GYATRI HYDEL PROJECTS PVT. LTD.

Ref.No. GHP/LICA/428/23

Subject :- Regarding diversion of 1.0188 hectares of forest land in favor of Gyatri Hydel Projects Pvt. Ltd., Mohalla Charpat, PO & Tehsil Chamba and Distt. Chamba HP for the construction of Banuala Baroond-I SHEP(2.00MW) within the jurisdiction of Chamba Forest Division Distt. Chamba HP (Online Proposal No. FP/HP/HYD/148103/2021) and Reply to observations thereof.

Reference- Online proposal No. FP/HP/HYD/148103/2021 EDSs raised by IRO Shimla on dated 15-05-2023

LAYOUT PLAN OF BANULA BAROOND-I SHEP (2.00 MW) IN DISTT CHAMBA (HP)

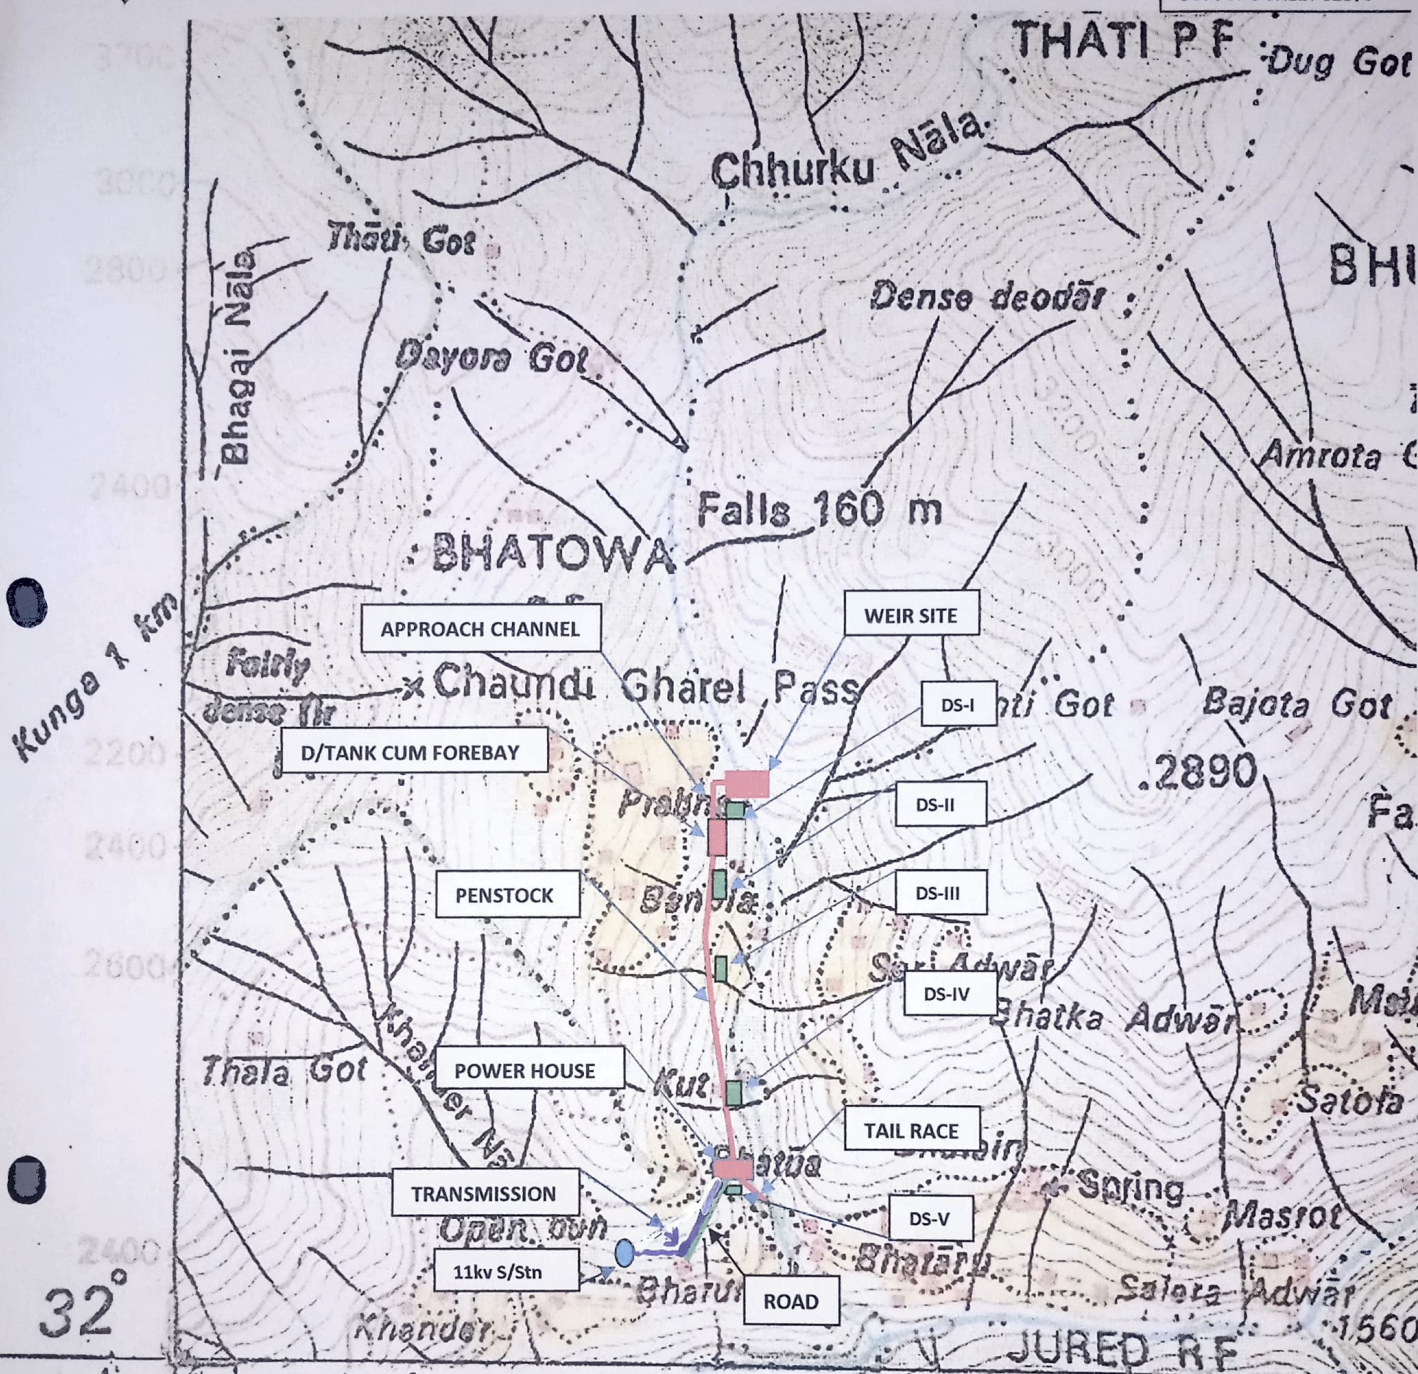
Sr. No.	OBSERVATIONS	REPLY
1	In the additional document, provided the area of the road is mentioned as 0.0872 hect, which is not matching with area mentioned for road in component wise breakup of Part-I. Needful correction is this regards may be done.	Needful correction has been done
2	The area of the Transmission line in component wise breakup is mentioned as 0.3868 hect. Which is not matching with the area for Transmission Line mentioned in additional document. Needful correction is this regards may be done.	Needful correction has been done
3	In KML file , the right of way (ROW) of both Road and Transmission Line has been taken together as single component , whereas in componet wise braekup of Part-I and Layout Plan these all mentioned saprately. Therefore , it may be clarified whether , ROW of Transmission is overlapping the ROW of Road or not. Needful corrections in this regard may be done.	The land for road and Transmission has been acquired commonly upto the length of 200M with saprate ROW for each component i.e Road and Transmission Line. Road (ROW 4.36M) Transmission Line (ROW 7M). Road Length $200 \times 4.36m = 0.872$ Hect. T/Line Length $200 \times 7m = 0.1400$ T/Line Length $44.85 \times 7m = 0.0314$ T/Line Length $280.20 \times 7m = 0.1962$ Total T/Line Area = 0.3676 Hect. Needful correction has been done in KML and Layout Plan
